December 2022

Smallbrook Ringway: environmental planning objection

Simulated view from planning application. The proposed high-rise towers would be over-bearing, in combination forming almost a high-rise wall, out of scale, and enormously carbon intensive.

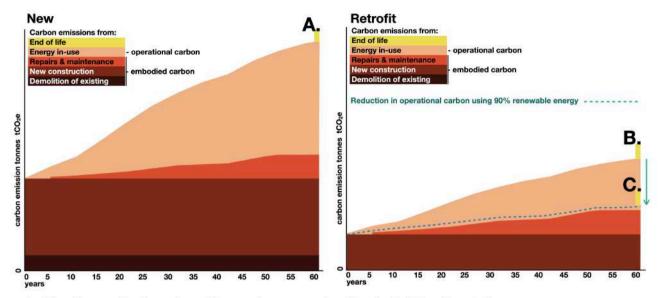
The simulated views do not demonstrate the towers "positively contribute to the Cityscape" (Volume 4, p.19): they would be over-bearing, forming almost a high-rise wall, out of scale, and enormously carbon intensive, in both their construction and operation. The repeated assertions that the existing built heritage has "low value" and impacts are "not significant" are subjective and highly questionable.
